ADDENDUM NO. FOUR
NCSB -FBMS

To the Plans and Specifications for:
Nassau County School Board – Project No. 98110-031
Fernandina Beach Middle School Kitchen / Dining Remodeling and Campus
Renovations/Enhancements

Date: October 18, 2018

2.5.1. Type “G” (Mechanical Room)

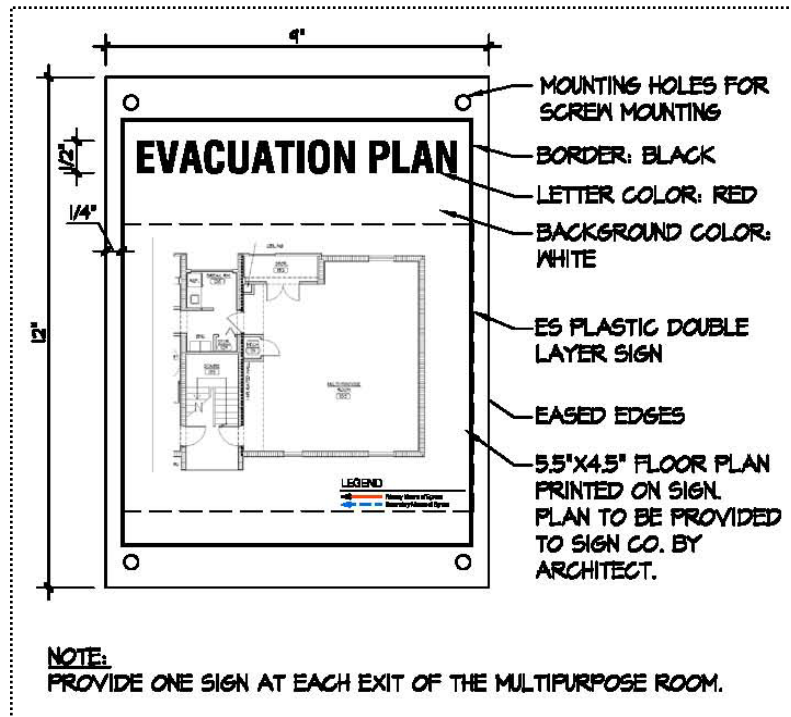
2.5. Provide hazardous area signs reading, “CAUTION HAZARDOUS AREA”, red background with white letters, at the following types of spaces: Electrical Rooms, Mechanical Rooms, IT Room, Server Room, and Fire Protection Chemical Storage Areas. Hazardous area signs shall be red background with white letters.

AS103

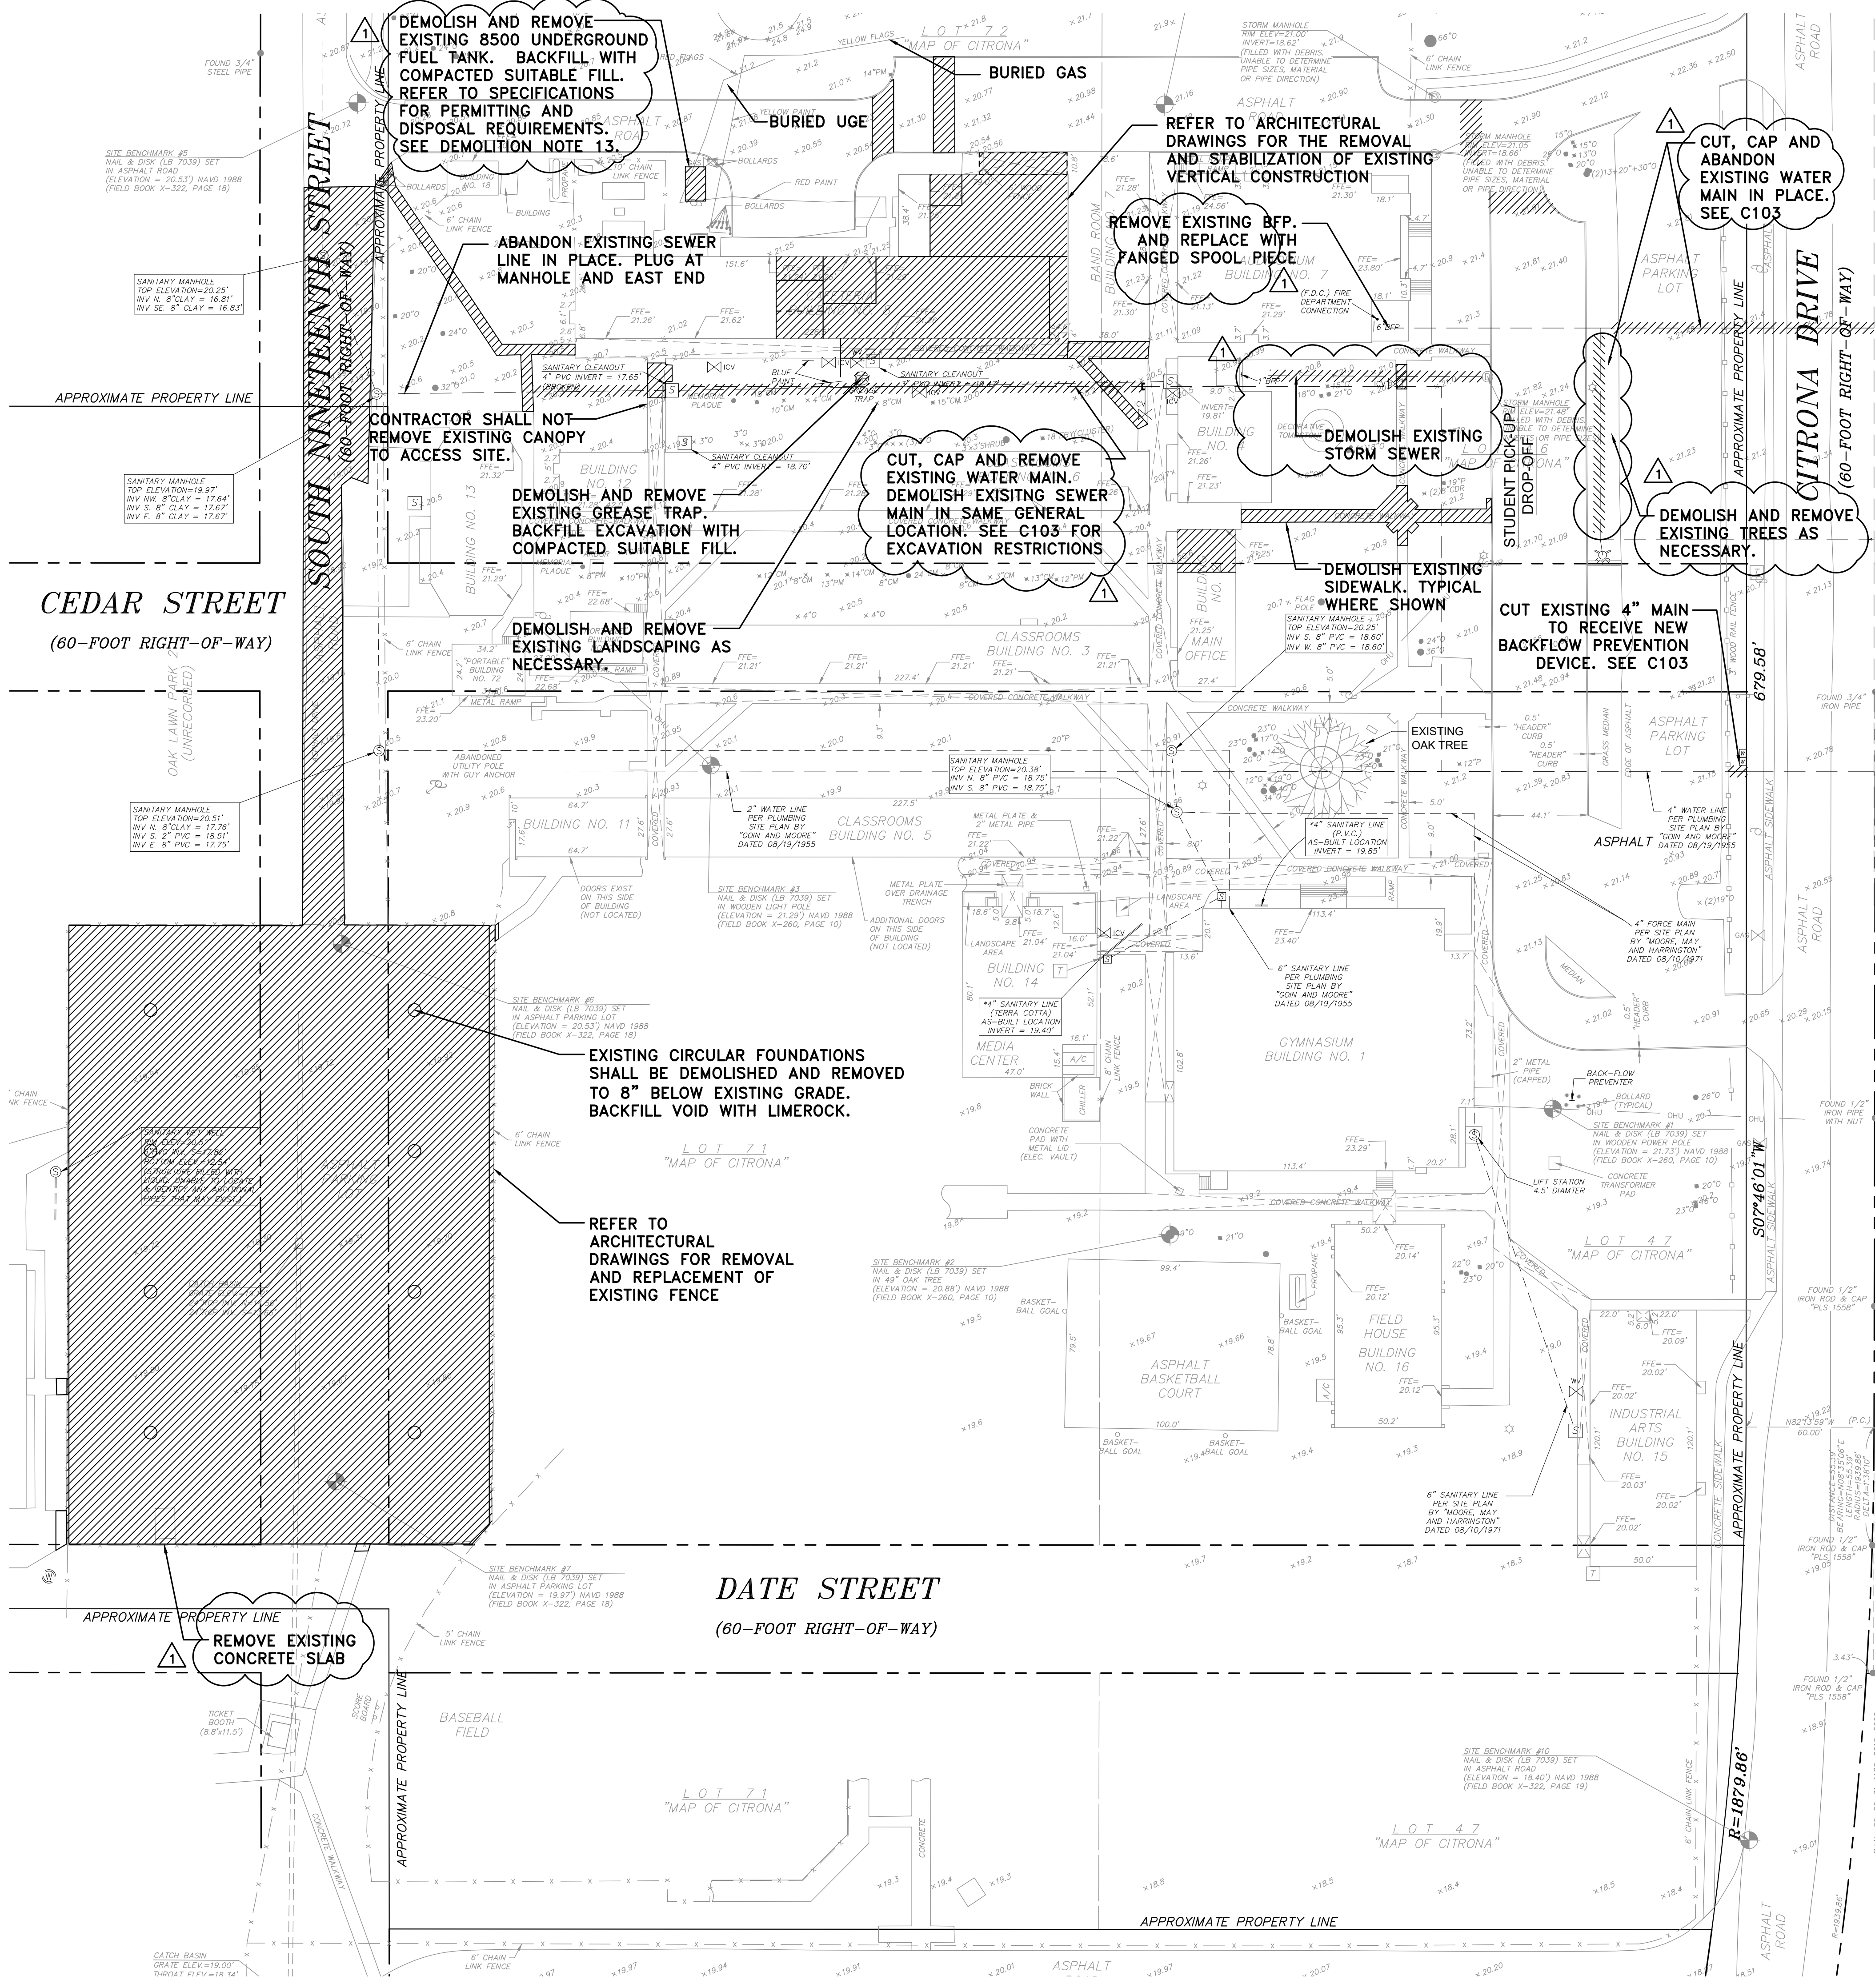
Replace Sheet AS103 with attached which adds a sign detail for Low-Emitting, Fuel-Efficient and High Occupancy Vehicles.
